HISTORIC AND DESIGN REVIEW COMMISSION

June 06, 2018

HDRC CASE NO: 2018-257
ADDRESS: 610 BARBE ST
LEGAL DESCRIPTION: NCB 2912 BLK 1 LOT N 99.02 FT OF 3
ZONING: RM-4,H
CITY COUNCIL DIST.: 1
DISTRICT: King William Historic District
APPLICANT: Melody Patrick/FDN Homes
OWNER: Macario Escamilla
TYPE OF WORK: Exterior modifications and fenestration changes
APPLICATION RECEIVED: May 11, 2018
60-DAY REVIEW: July 10, 2018
REQUEST:

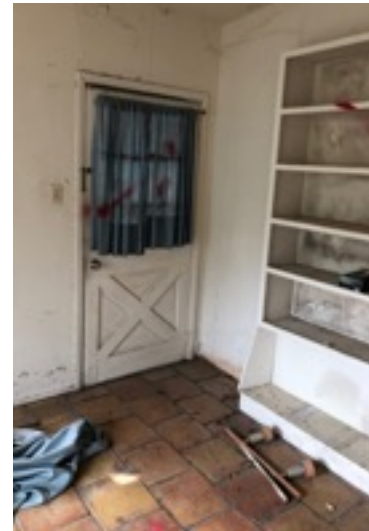
2. Remove sliding glass doors - replace with historic window

- At some point in time the original porch was enclosed for additional square footage and a sliding glass door was added in addition to the second back door.
- The doors are not original and become unnecessary as the space will become a master ensuite.

- The door opens to the side yard which steps down into the fence along the side of the property. The distance between the exit and the gate is less than 24 inches.
- A window removed from the middle bedroom will be used in place of the sliding door.

- c. NON-HISTORIC SLIDING DOOR – The applicant has proposed to remove the non-historic sliding door on the rear side of the property and install a salvaged window existing on the structure. Staff finds the removal of the non-historic element and the relocation of the salvage window consistent with the Guidelines.

- i. The removal of the aluminum bay window.
- ii. The removal of the sliding door and installation of salvaged window on site.
- iii. The removal of the rear door opening on the rear addition, with the stipulation that the period-appropriate door is reused on site.
- iv. The removal of the side addition and installation of the two wood one-over-one windows with the stipulation that the new windows are consistent with the Guidelines and final specifications be submitted to staff.
- v. The installation of fiber cement shingle siding where asbestos is deteriorated or missing with the stipulation that the new siding matches the asbestos siding in texture and form.

4. Replace Non-Conforming Window to Replace with Proper Egress

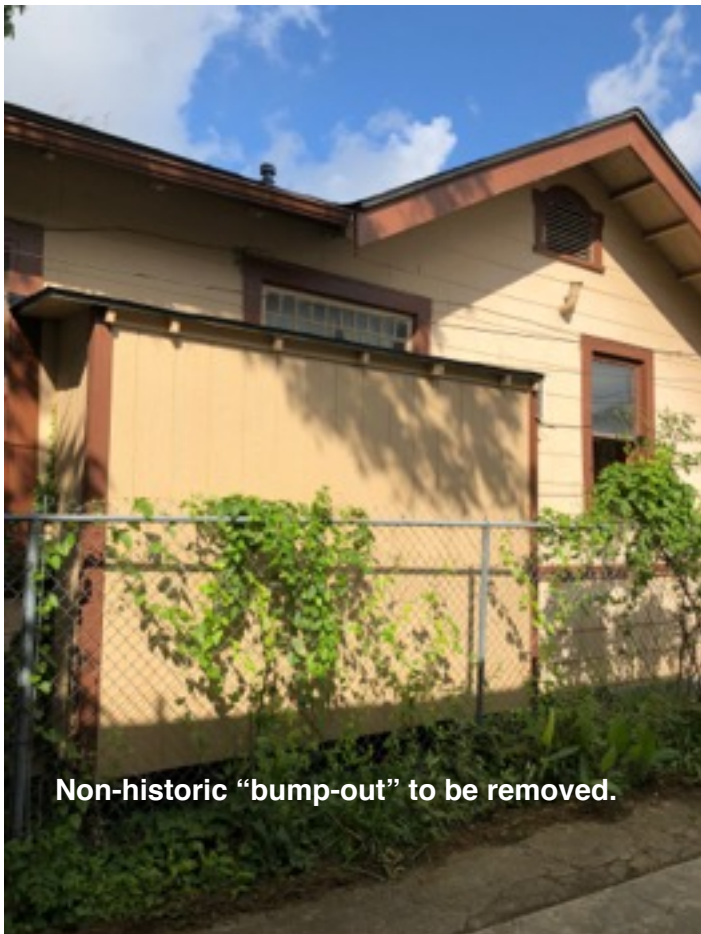
- The existing window in the middle bedroom measures 55" x 23 inches and is 76" from the floor. It does not currently meet International Building Code as an egress because it is more than 44" off the floor.
- The window will be reused in the master bath in the back of the home.

- e. SIDE ADDITION AND WINDOW – The applicant has proposed to remove the non-historic side addition and historic wood window to install two one-over-one wood windows on the original side wall. The side-addition currently functions as bump-out closet for the existing bedroom. The historic window featuring 55” wide by 23” tall is located 76” from the floor and does not meet the International Building Code as an egress for a bedroom. Staff finds the removal of the non-historic addition, the installation of new one-over-one wood windows, and the relocation of the historic window consistent with the Guidelines. The final window specifications must be submitted to staff for review and approval. Meeting rails must be no taller than 1.25” and stiles no wider than 2.25”. There should be a minimum of two inches in depth between the front face of the window trim and the front face of the top window sash. This must be accomplished by recessing the window sufficiently within the opening. Window trim must feature traditional dimensions and architecturally appropriate sill detail. Window track components must be painted to match the window trim or concealed by a wood window screen set within the opening.
